| T.I. no.: 2017 - 25 Updated: - | Topic: SC Soul left side cooling unit, UC, CM and UC+CM |

| Date: 16.11.2017 | Priority | Need for action |
| Affected machines: SC Soul | High | As soon as possible |
| From serial number: 1745xxxxxx | Medium | On next visit to the machine |

Fig. Right standard side cooling unit

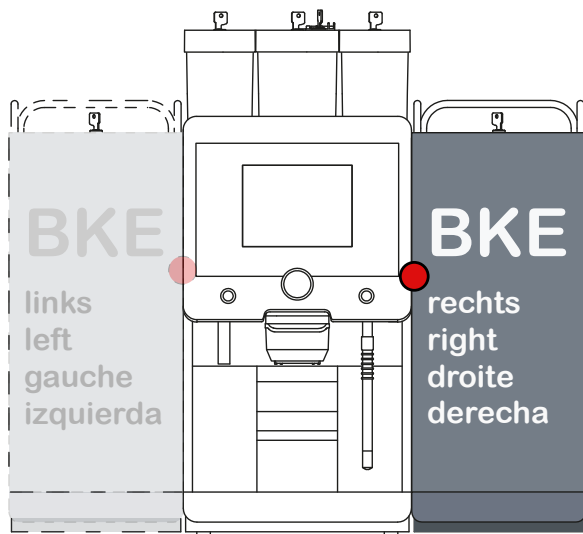
079811 contains the accessories for the side cooling unit if it is placed to the left or right of the coffee machine.

- No conversion is required for the right side cooling unit (standard); the milk hose only has to be shortened to the required length of 28 cm.
- The hose guide of the coffee machine must be retrofitted from the right to the left for the left side cooling unit.
- ▶ For a more detailed description, see conversion instructions 020798.

Fig. Left or right under-counter cooling unit with guide

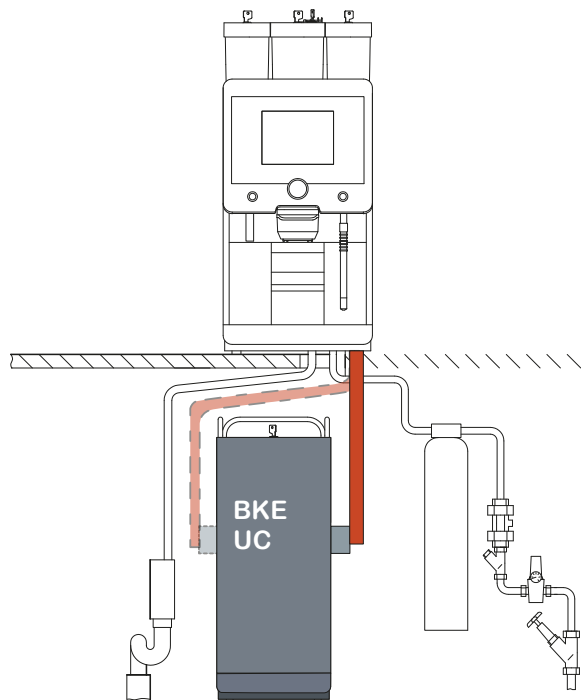
079812 contains the accessories for the side cooling unit if it is placed under the counter.

- Clarify installation-site counter break through, note the SCSoul installation plan.
- Guide the milk hose to the under-counter cooling unit as directly as possible.
- ▶ For a more detailed description, see conversion instructions 020798.

Fig. Side cooling unit with Centre Milk

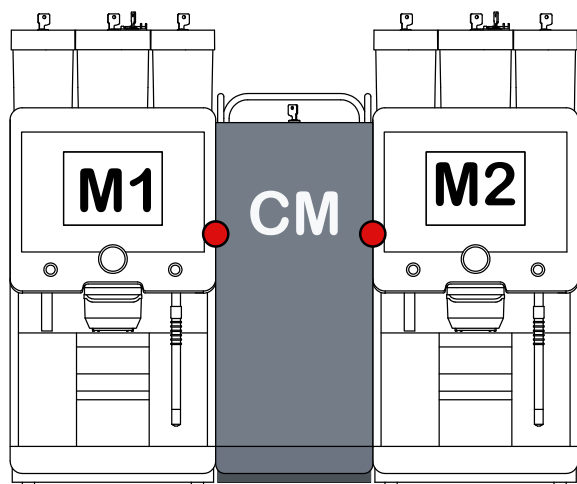
079813 contains the accessories for the side cooling unit with the "Centre Milk" function.

The Centre Milk side cooling unit also contains CAN nodes connections for the 2nd coffee machine. In addition, the milk container cover is equipped with 2 connections and 2 riser pipes.

Always make sure that beverages cannot be dispensed from either machine during the cleaning process, note the sticker.

- No conversion is required for the right side cooling unit (standard); the milk hose only has to be shortened to the required length of 28 cm.
- The milk hose guide must be led to the left for the [M2] coffee machine on the right side.
- Attach enclosed warning sticker to the cooling unit door.
- ▶ For a more detailed description, see conversion instructions 020798.

Fig. Under-counter cooling unit with Centre Milk

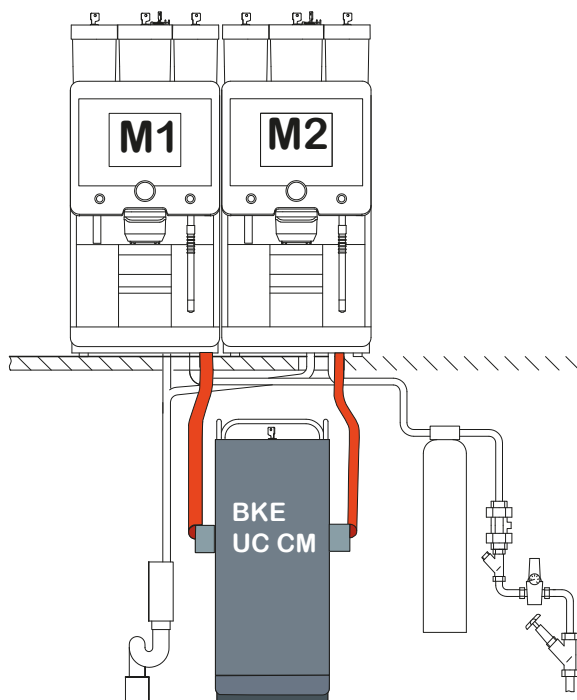
079814 contains the accessories for the under-counter cooling unit with the "Centre Milk" function.

The Centre Milk under-counter cooling unit also contains CAN nodes connections for the 2nd coffee machine. In addition, the milk container cover is equipped with 2 connections and 2 riser pipes.

Always make sure that beverages cannot be dispensed from either machine during the cleaning process, note the sticker.

- Clarify installation-site counter break through, note the SCSoul installation plan.
- Guide the milk hose to the under-counter cooling unit as directly as possible.
- Attach enclosed warning sticker to the cooling unit door.
- ▶ For a more detailed description, see conversion instructions 020798.

Fig. Sheet079524 hose guide UC KE

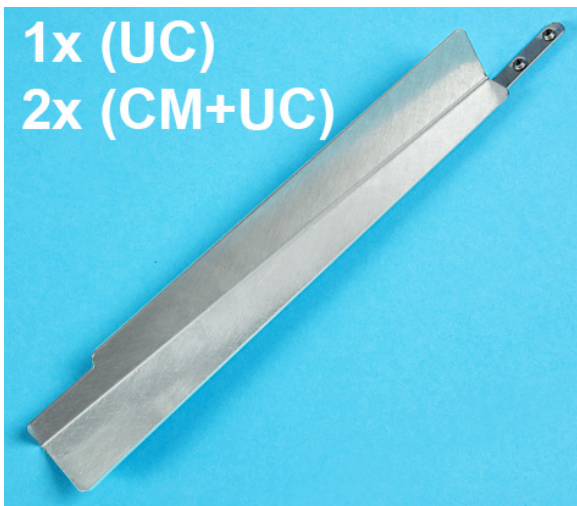
Sheet 079524 is pre-installed starting in CW45 2017 and is not enclosed with any set.

Sheet 079524 must be ordered separately for machines with serial numbers up to SN 1744 xxxxxx which need to be retrofitted.

Two matching screws 00.0047.3356 left screws PH M4x5 Inox should be ordered as well.

2x 079524 and 2x 00.0047.3356 are required for Centre Milk and under-counter cooling unit.
